Technical Bulletin

Model
911 C2/C4
Turbo

Engine Cooling Fan Hub

Number
9306

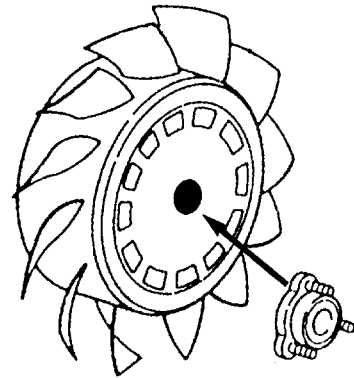
General Information: The engine cooling fan hub (with bearing) is now available as a separate part.

Repair Information: The hub can be removed and installed using a normal shop press. The hub should be used when a vehicle is being repaired for a noisy or damaged fan bearing or fan hub.

The fan hub can be installed on engine cooling fans with the following part numbers:

Parts Information: Engine cooling fan hub 964 106 051 30
